NRL/MR/7441--94-7550

Digital Mapping, Charting, and Geodesy Analysis Program Technical Review of Interim Terrain Analysis Data Set Prototype 1

August 12, 1994

Figure 1. Common Open Water (SA010) from SDRAREA.AFT

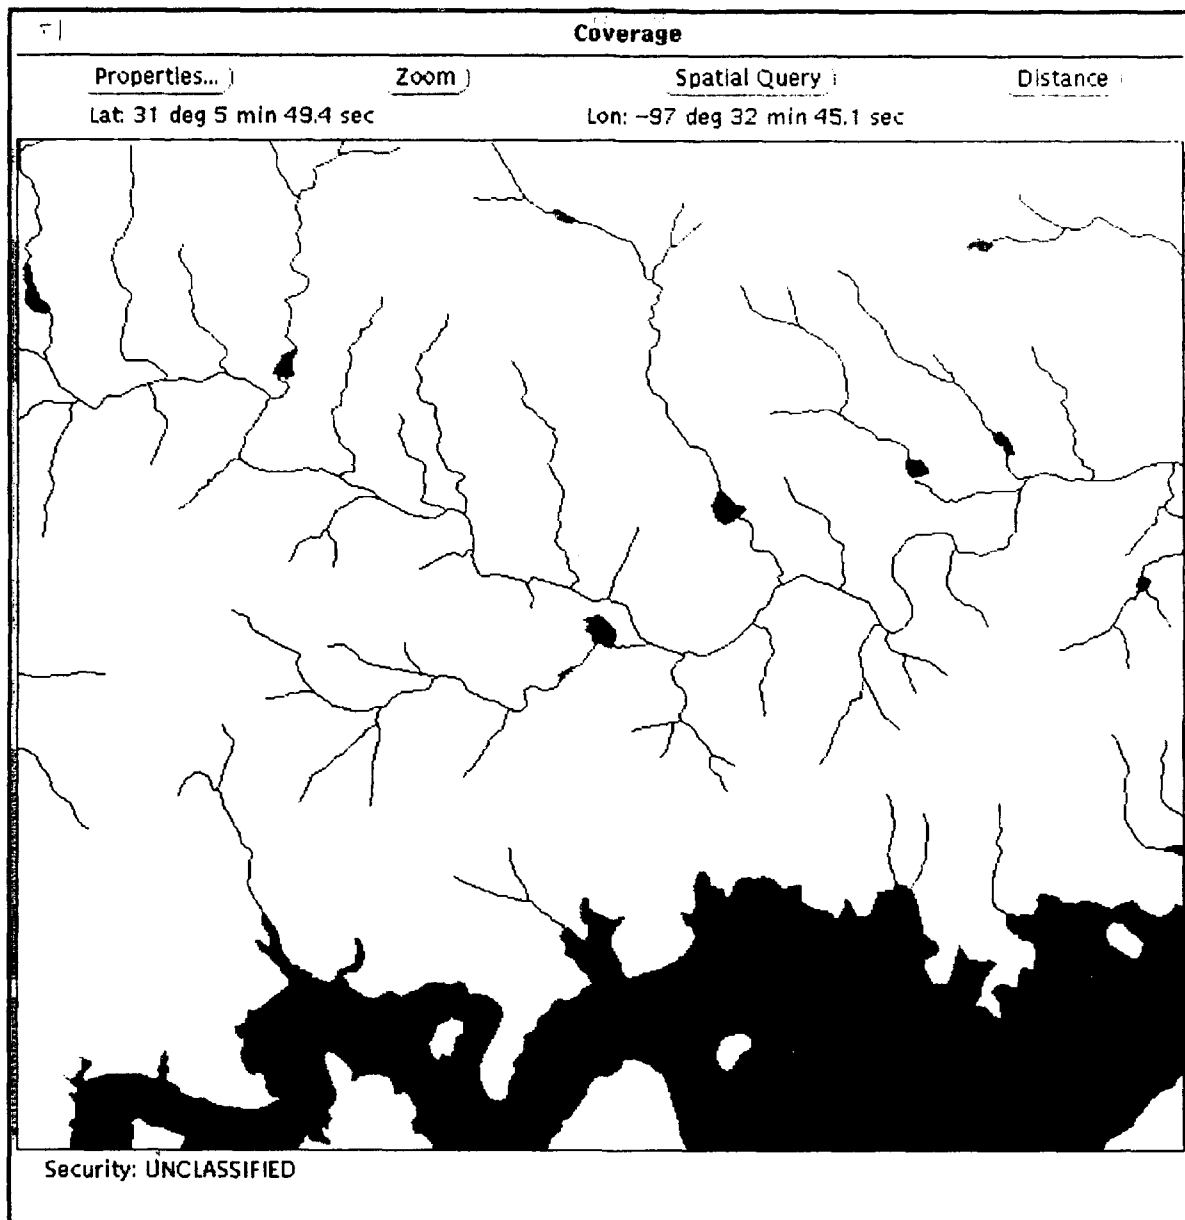
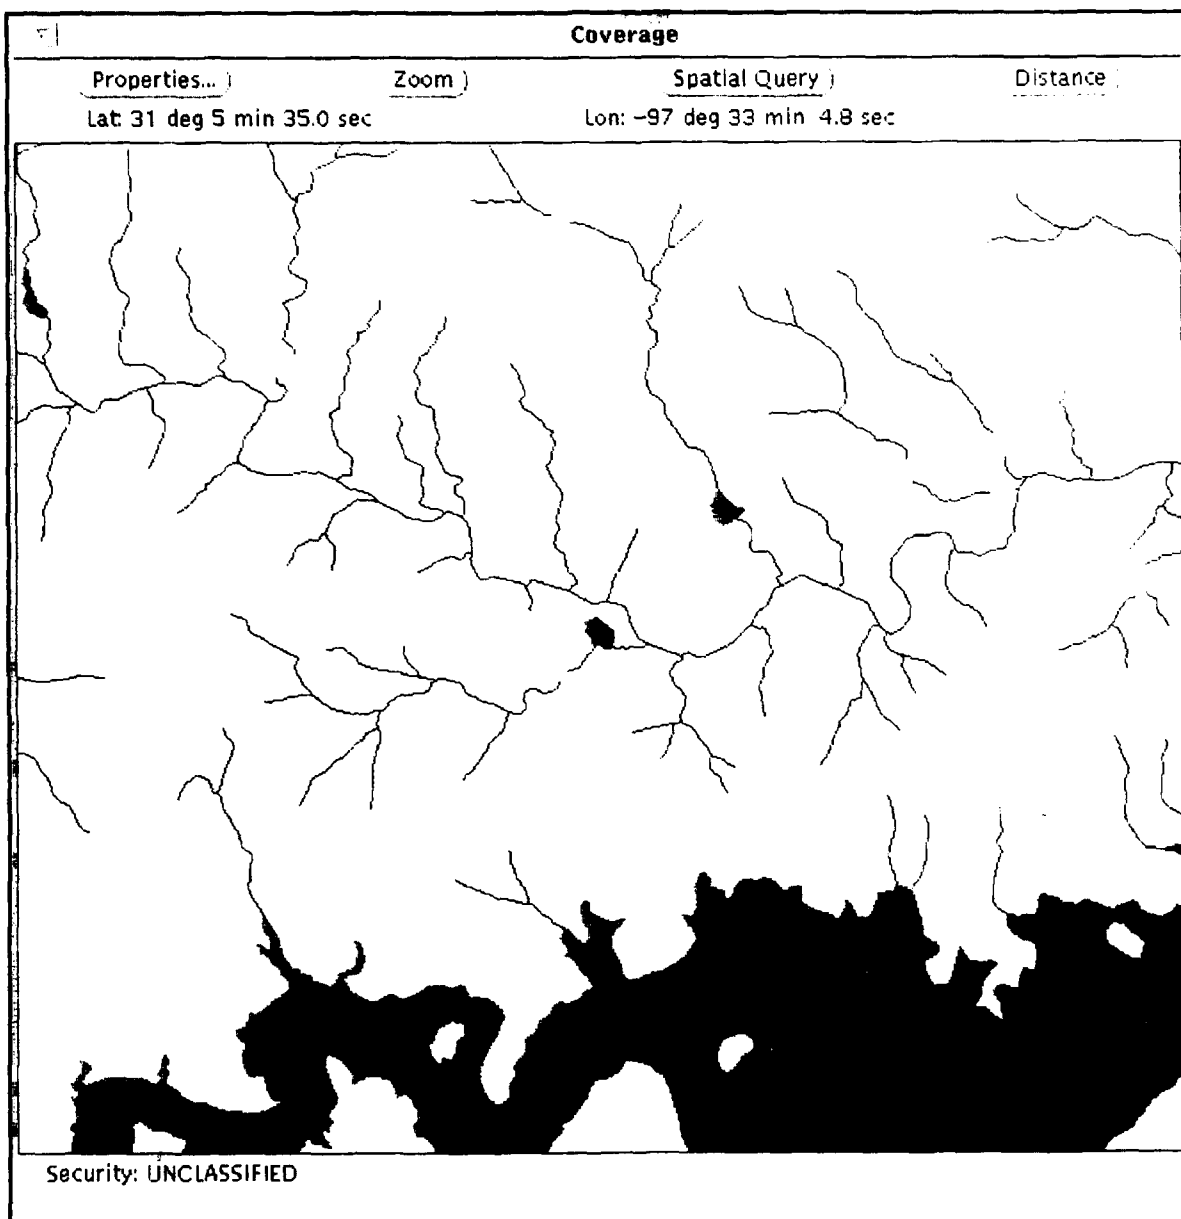
Data are found in SLWAREA, VEGAREA, and SDRAREA. When SA010 is plotted, some of the resulting open water areas do not appear in all coverage. There are approximately 30 features found only in SDRAREA. For example, a small lake (0.4 miles long, 0.1 miles wide) appears only in SDRAREA at 31° 8' 0.7" N, 97° 36' 36.8" W.

The problem appears to be primarily due to the definition of "Open Water." In the surface drainage coverage, where Rivers are stored, certain wide areas in the rivers are defined as "Open Water," while in other coverages both of these areas and the Rivers are not defined. This results in a difficult to interpret set of coverages. For instance, if SA010 in VEGAREA is used to display lakes and BH140 (Rivers) are displayed from SDRAREA, there will be gaps in some of the Rivers. Examples of this problem are shown in Figs. 1 and 2. Note that in Fig. 2 not only are several lakes missing but the Rivers (BH140) now have unexplained gaps in them.

Figure 3. Built-up Areas (AL020) in Red

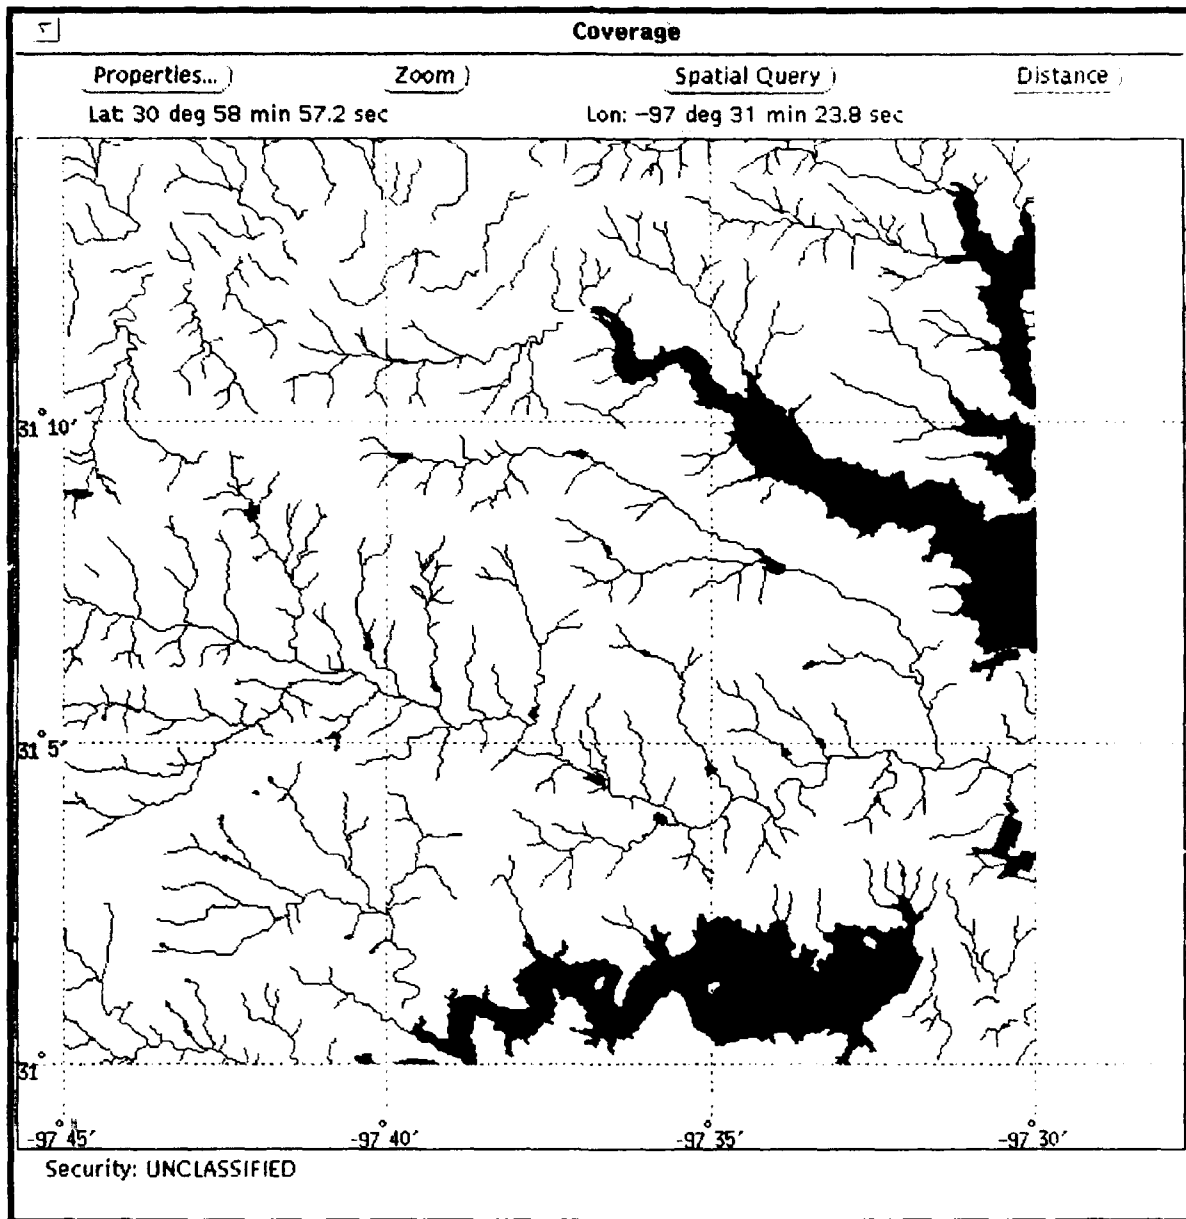
- There is a database error in the Built-up Areas table. When the feature Built-up Areas is displayed, the following face appears:
 Face 34:
 VGWAREA.AFT
 ID-Row Identifier: 7
 FAC-ID-34
 F_CODE- SA010.
 In fact, it is a lake that is displayed, but it appears with other Built-up Areas. This is shown in Figure 3. The feature AL020 (Built-up Areas) from VGWAREA.AFT is displayed in red.

Figure 4. Rivers in Area and Line Feature Classes

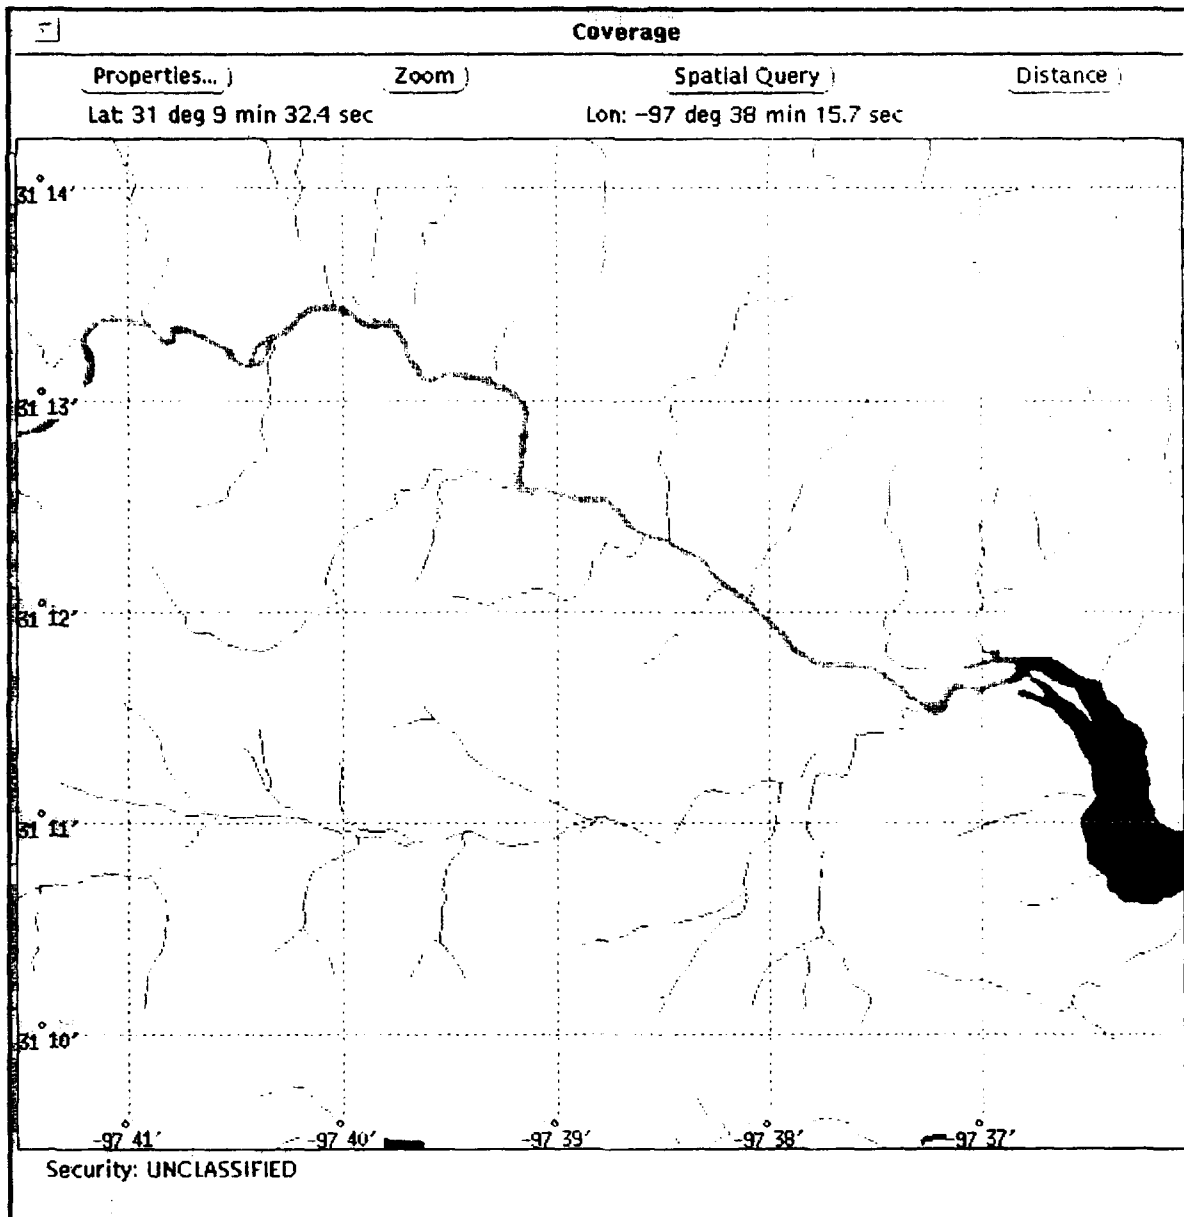
- It is not clear when a river is a line or area feature. As shown in Figure 4, there is a significant river area feature among the river line features. It is recommended that the criteria for coding river features be specified.
